ADDENDUM NO. 01
April 27, 2026

PROJECT: Baton Rouge Terminal Interior Upgrades
 9430 Jackie Cochran Dr.
 Baton Rouge, LA 70811

ARCHITECT: Washer Hill Lipscomb Cabaniss Architecture (LA) LLC, WHLC Architecture
 1744 Oakdale Drive
 Baton Rouge, LA 70810

A15.6

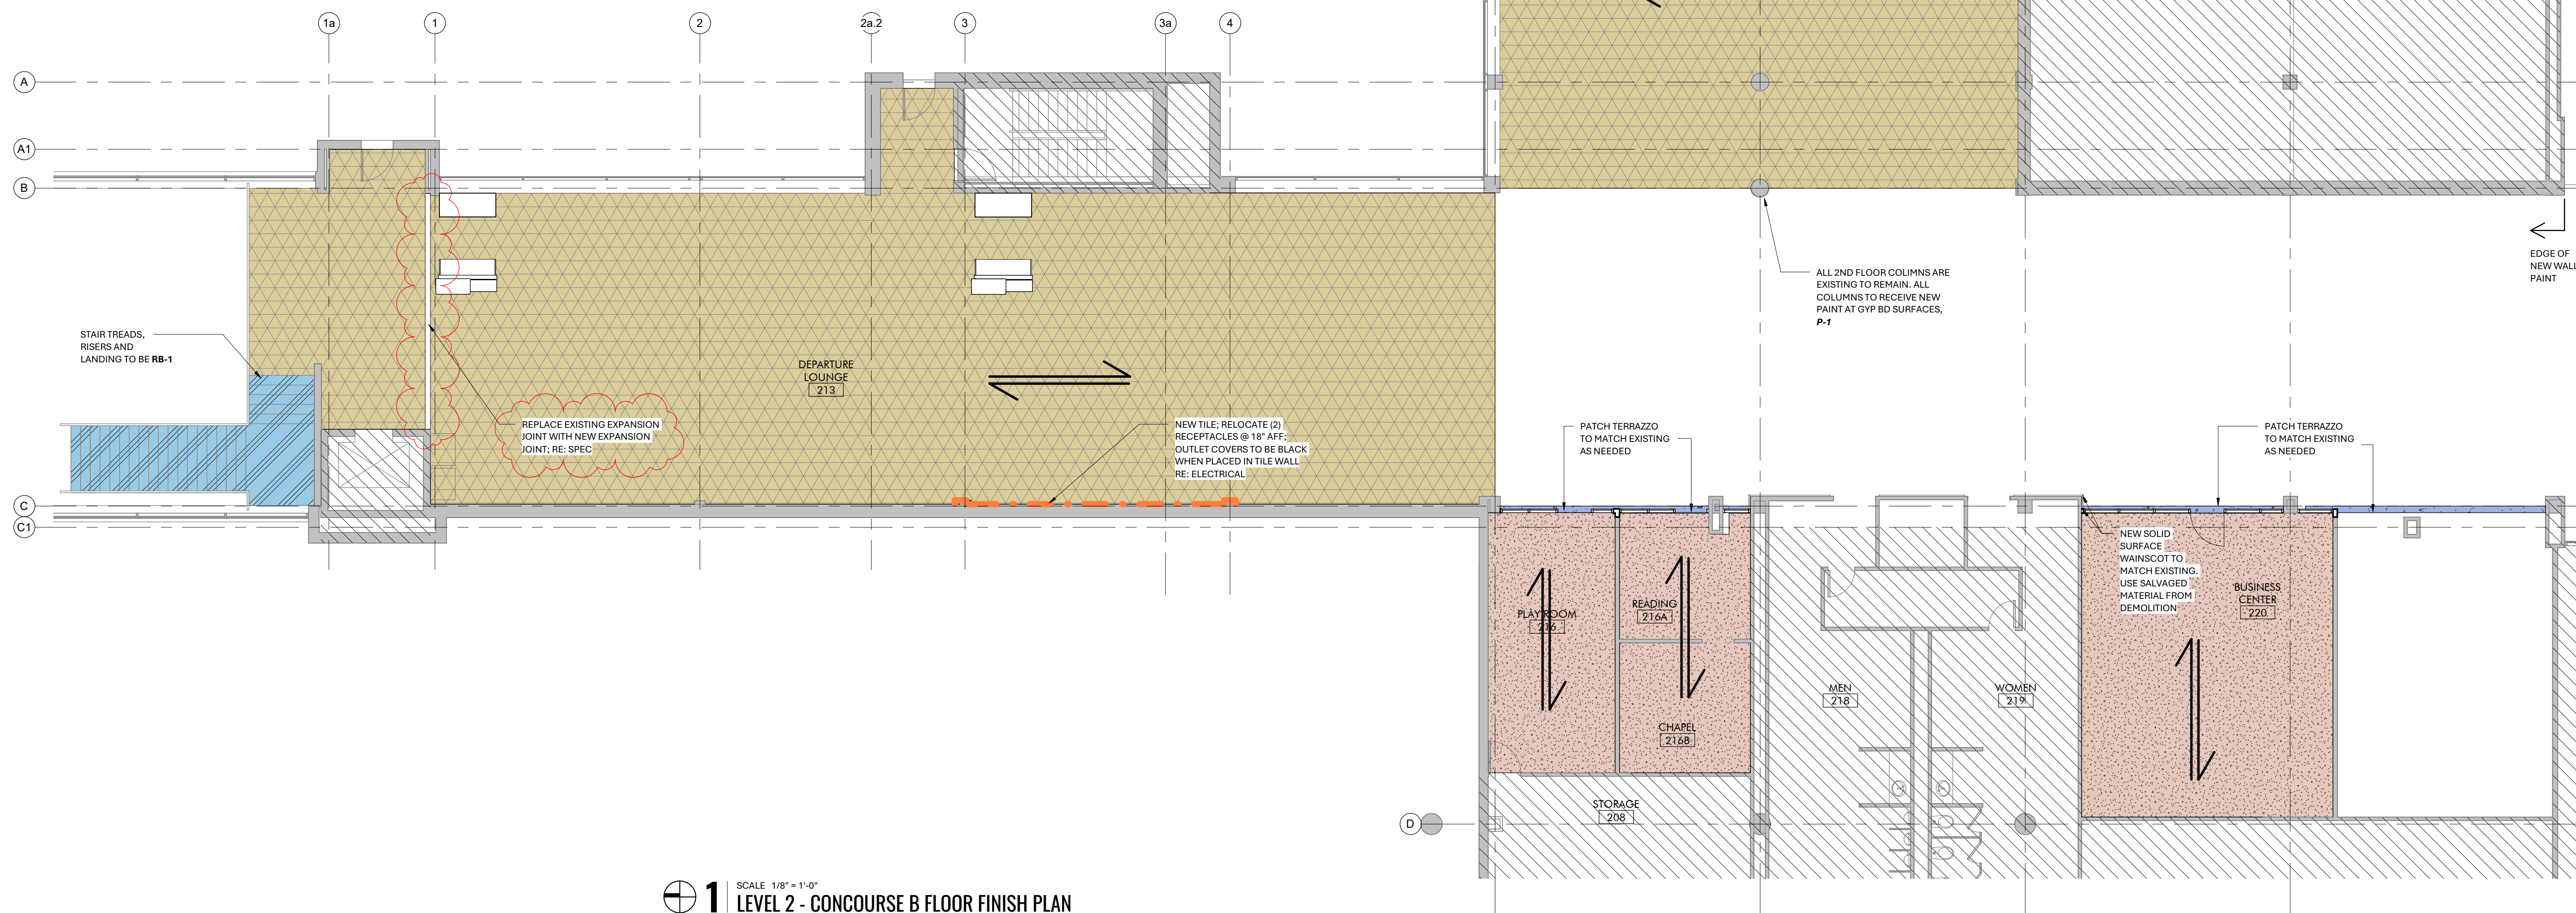
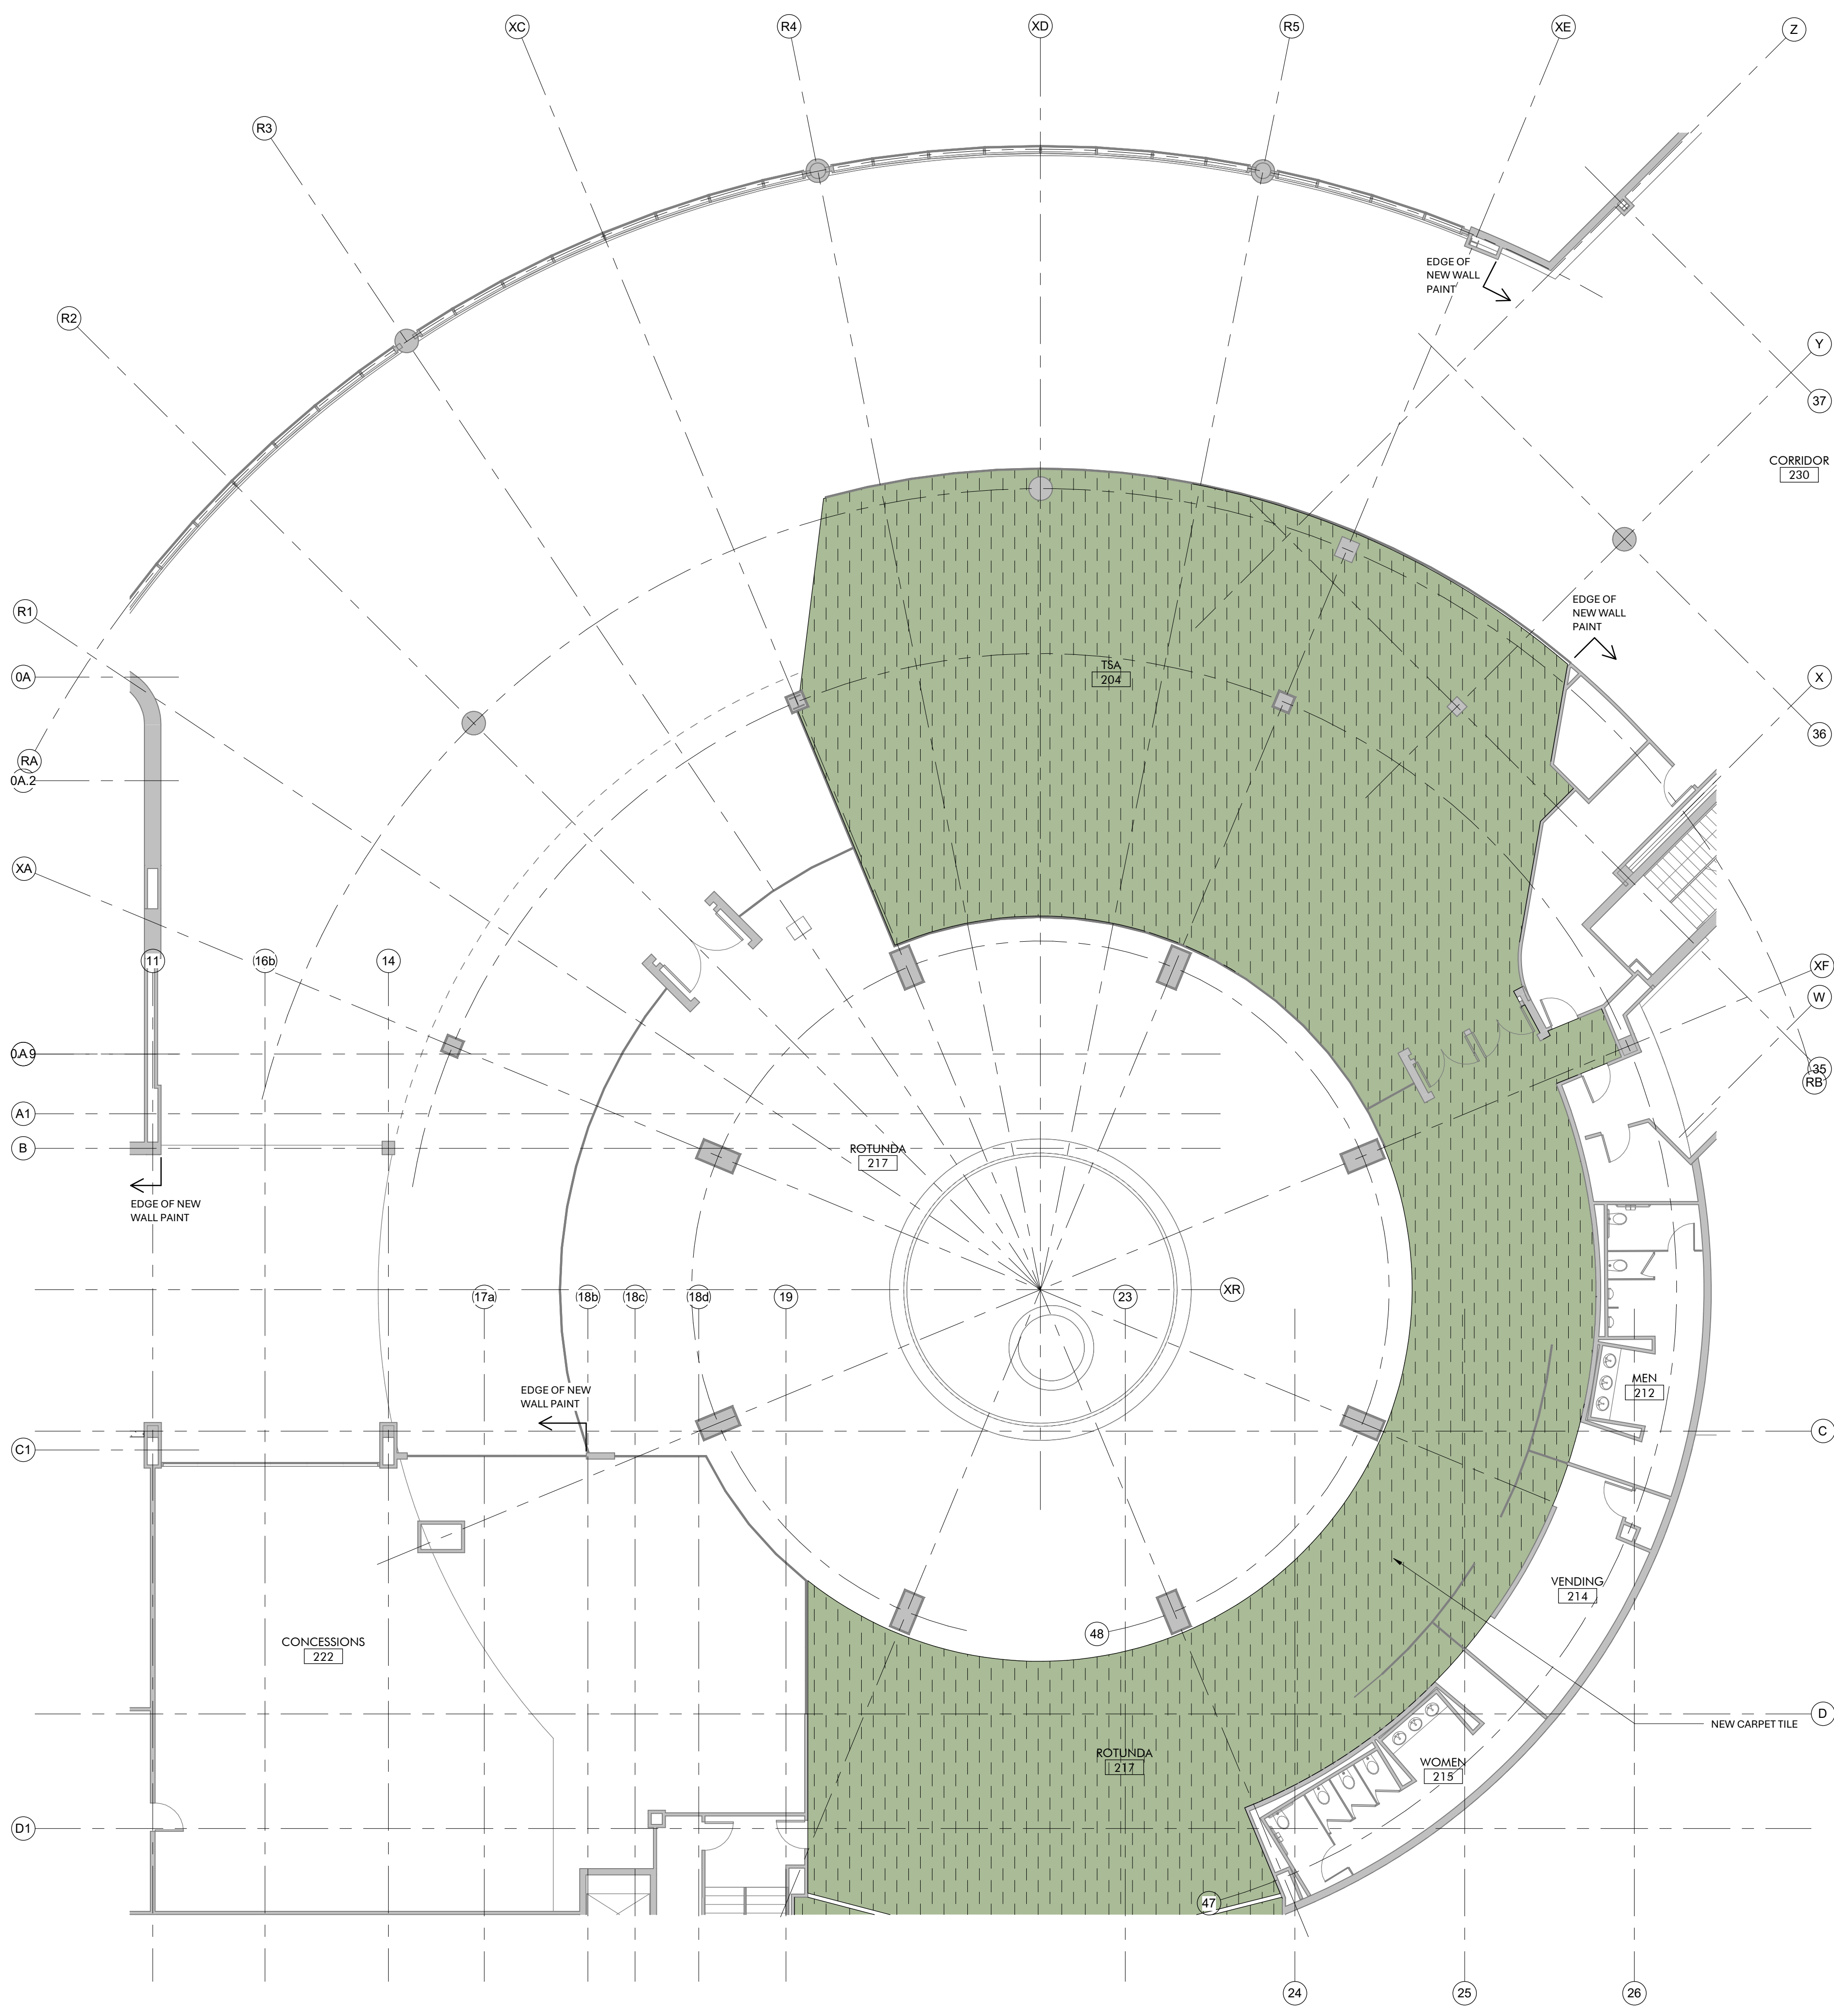
Sheet A15.6: See attached **revised** sheet which clarifies the expansion joint scope at Concourse B. **1 page** (24”x36”)

1 SCALE 1" = 10'-0"
LEVEL 2 - ROTUNDA FLOOR FINISH PLAN

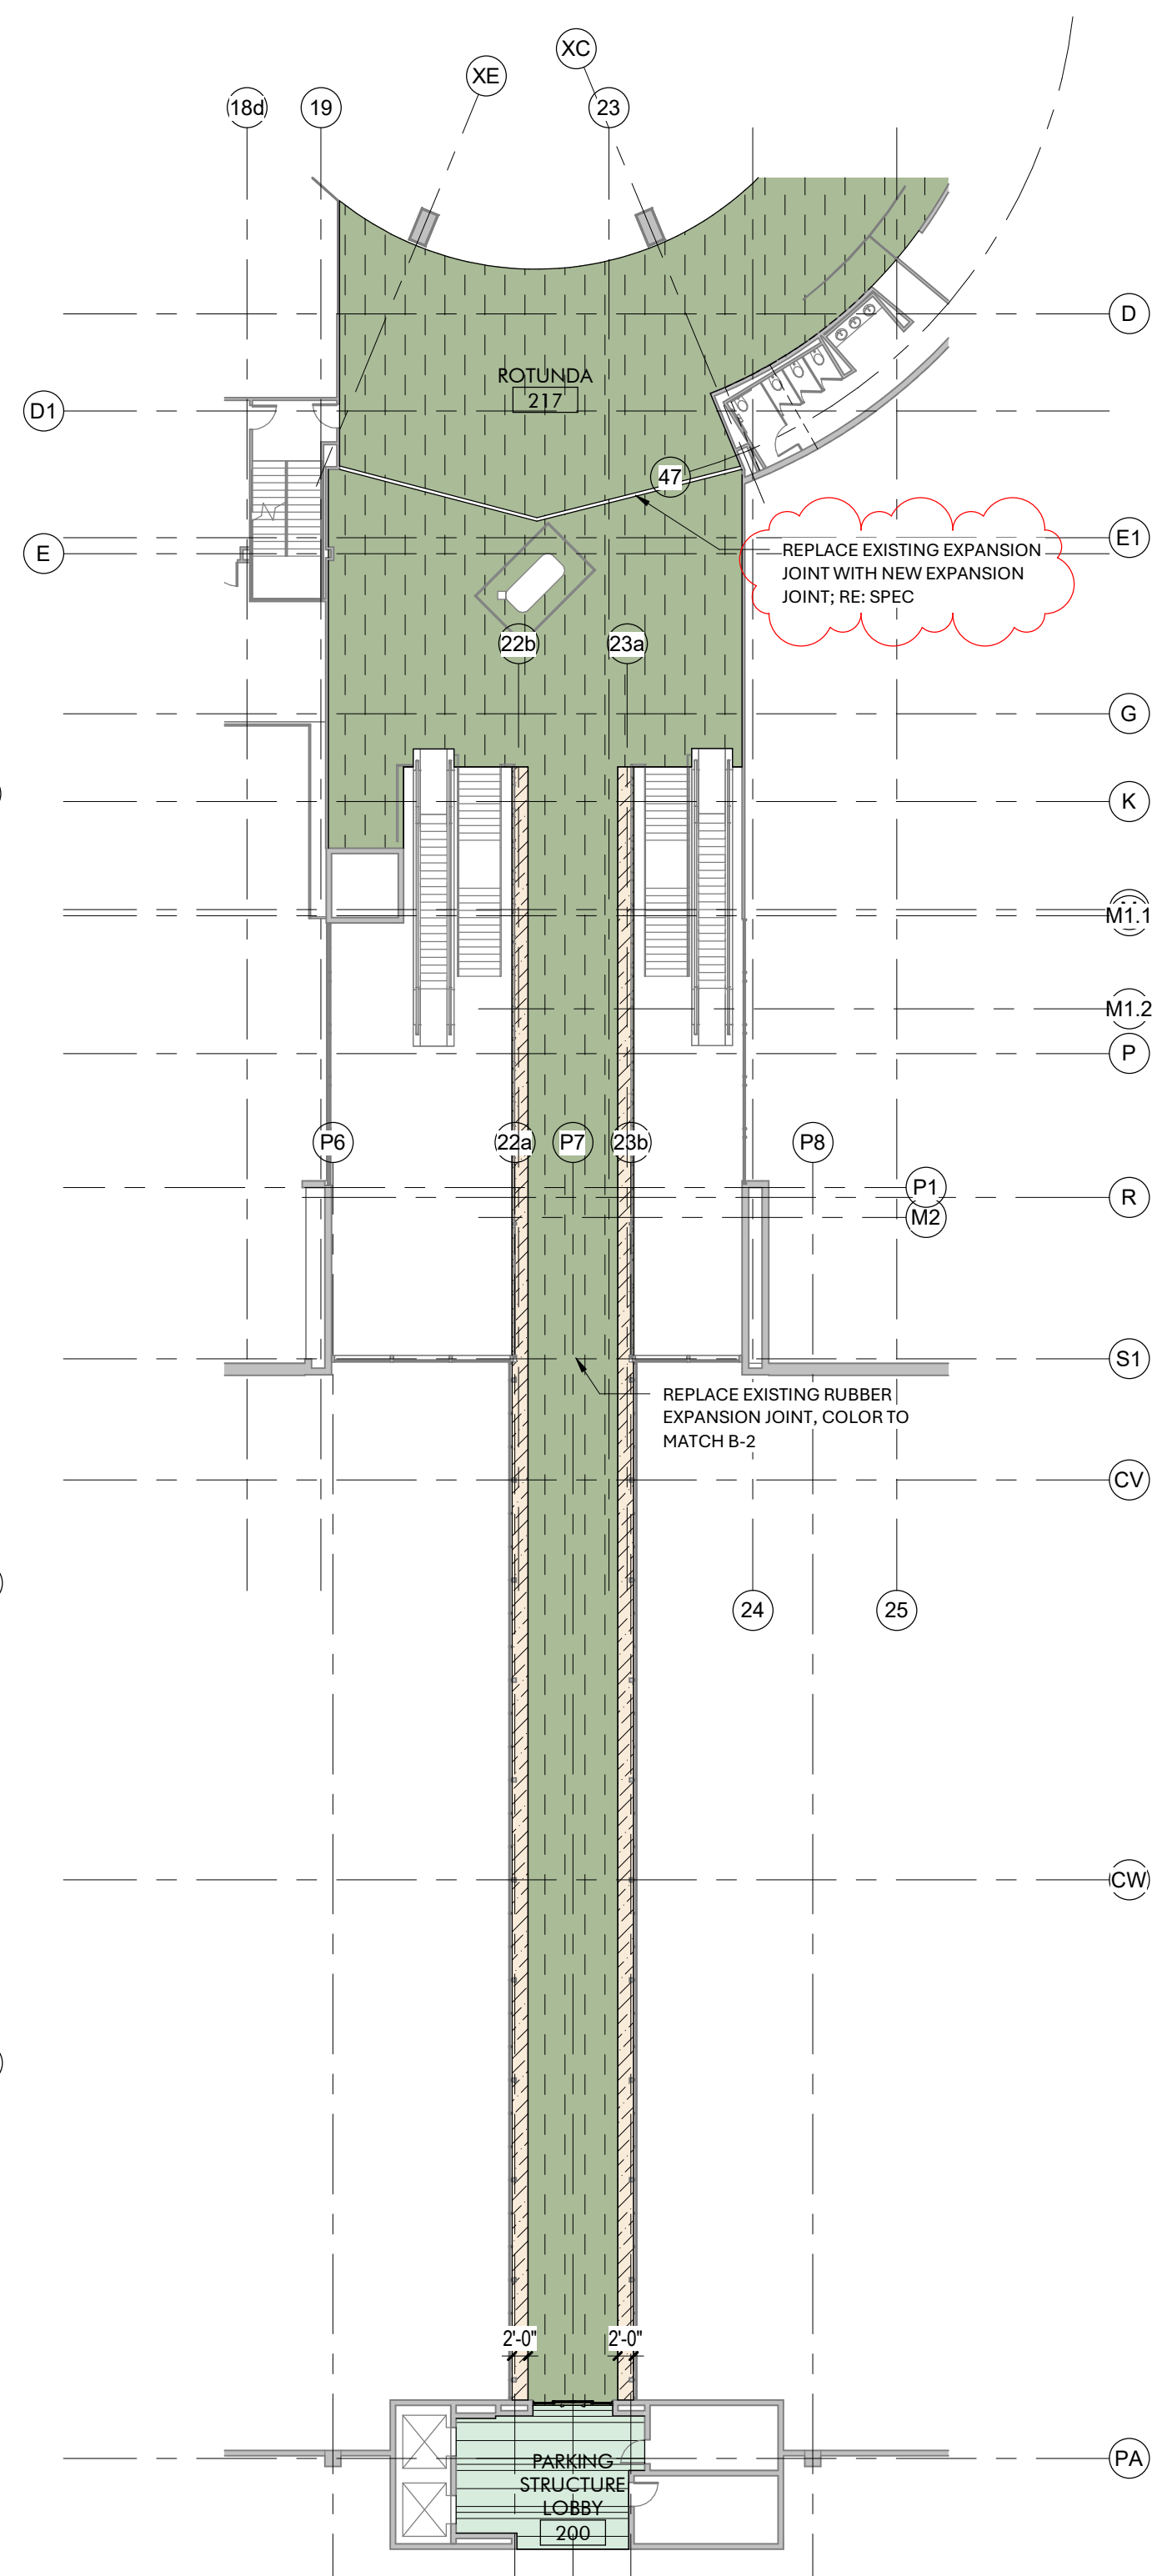
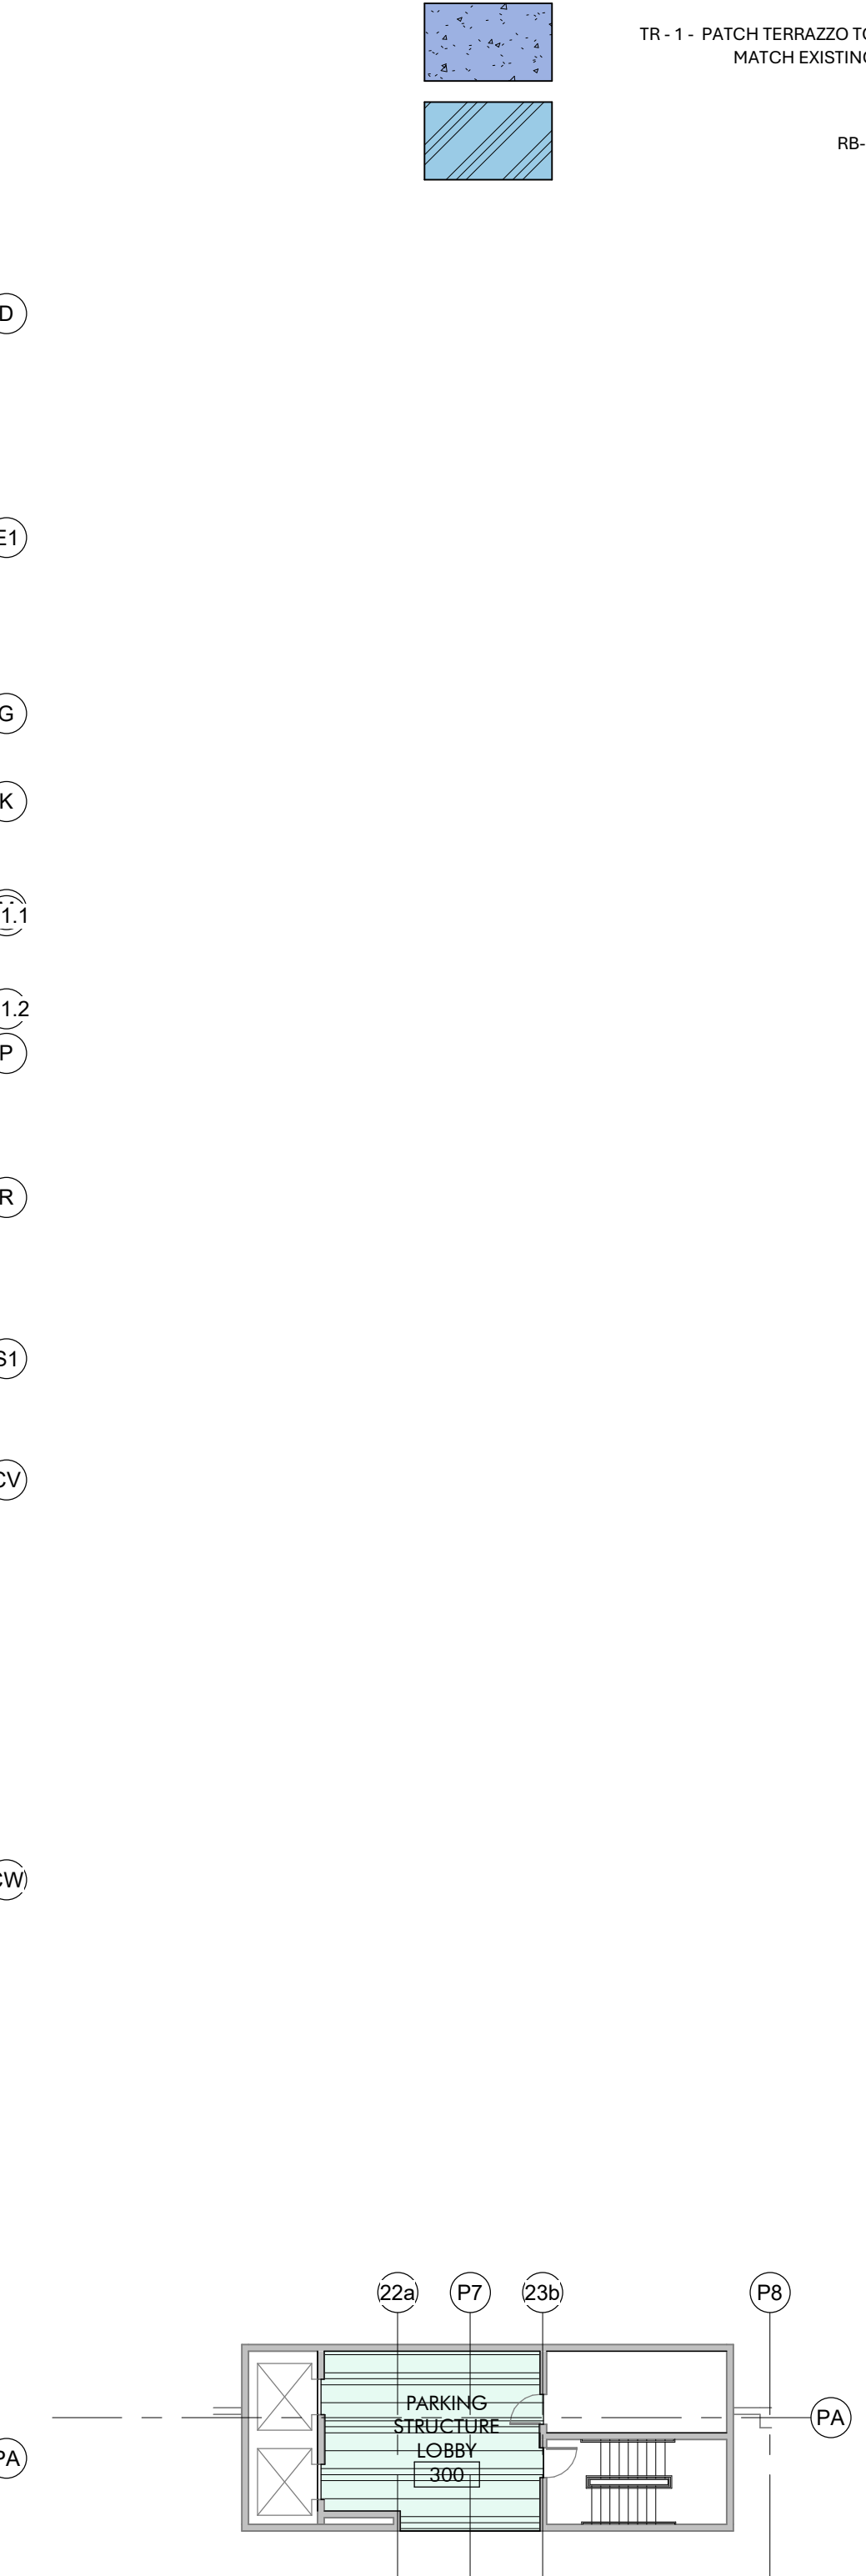
Sheet A15.7: See attached **revised** sheet which clarifies the expansion joint scope at the Pedestrian Bridge and Rotunda. **1 page** (24”x36”)
